Sashimi Federal #1 1160' FNL & 1760' FWL, Section 25, T26S, R25E Eddy County, New Mexico

PECOS DISTRICT CONDITIONS OF APPROVAL

OPERATOR'S NAME:	Marbob Energy Corp
LEASE NO.:	NM-104666
WELL NAME & NO.:	1-Sashimi Federal
SURFACE HOLE FOOTAGE:	1160' FNL & 1760' FWL
BOTTOM HOLE FOOTAGE	'FL& 'FL
LOCATION:	Section 25, T. 26 S., R 25 E., NMPM
COUNTY:	Eddy County, New Mexico

EA#: NM-520-07-0643 Lease #: NM-104666 Marbob Energy Corporation Sashimi Federal No.1

Figure 1 – Cross Sections and Plans For Typical Road Sections

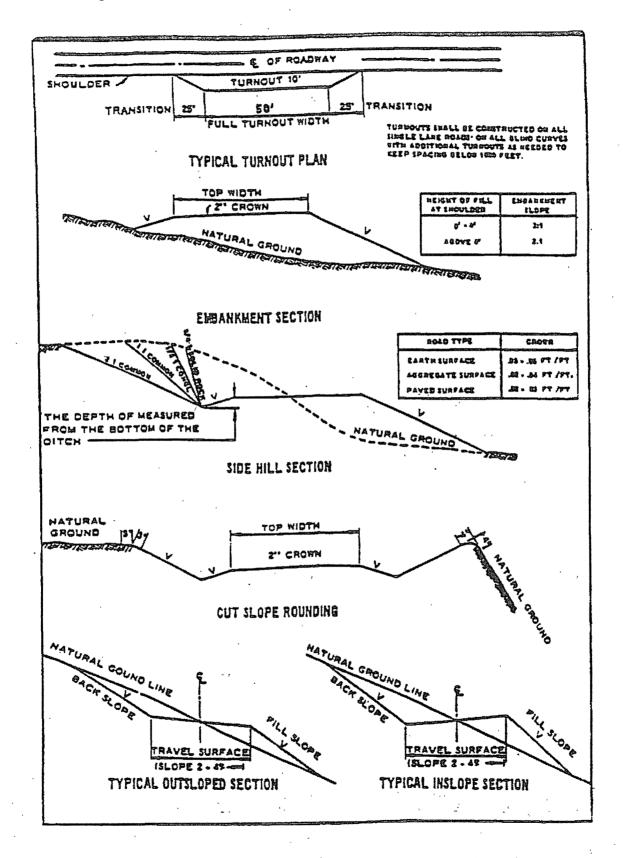
Crowning shall be done on the access road driving surface. The road crown shall have a grade of approximately 2% (i.e., a 1" crown on a 14' wide road). The road shall conform to Figure 1; cross section and plans for typical road construction.
